Item Name: Aux Tank Assembly

DART SERVICE INSTRUCTION

TO AMEND INSTRUCTIONS FOR CONTINUED AIRWORTHINESS

ICA-D350-794 REV. 6 OR EARLIER
 REF. TCCA STC: SH05-4
 REF. FAA STC: SR02794NY
 REF. EASA STC: 10031514
 REF. BRAZIL STC: 2002S09-07/-08
 REF. AUSTRALIAN STC: ASR063SY

ICA FIGURE 28-2 IS

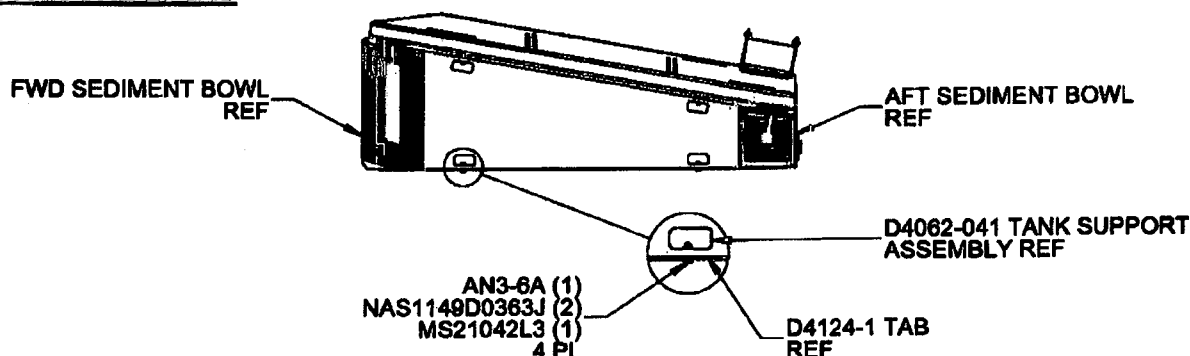
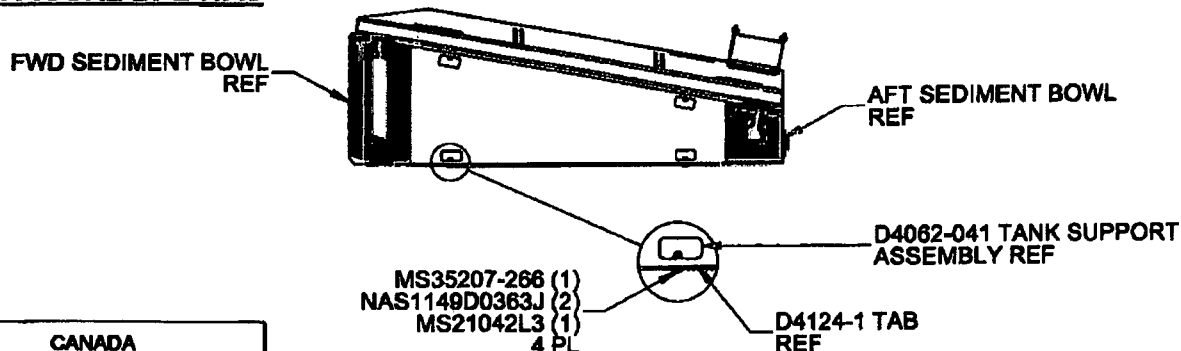
The purpose of this Dart Service Instruction is to amend hardware changes to tank assembly D350-794-141 at change 002 and subsequent. The NAS1149D0363J washers under the AN3H5A bolts have been replaced by NAS1149D0332J washers to allow greater thread grip. The MS35207-266 screws have been replaced by AN3-8A bolts to prevent the screw heads from becoming stripped during installation.

Revise ICA-D350-794 Figure 28-2 and Figure 28-3 as follows:
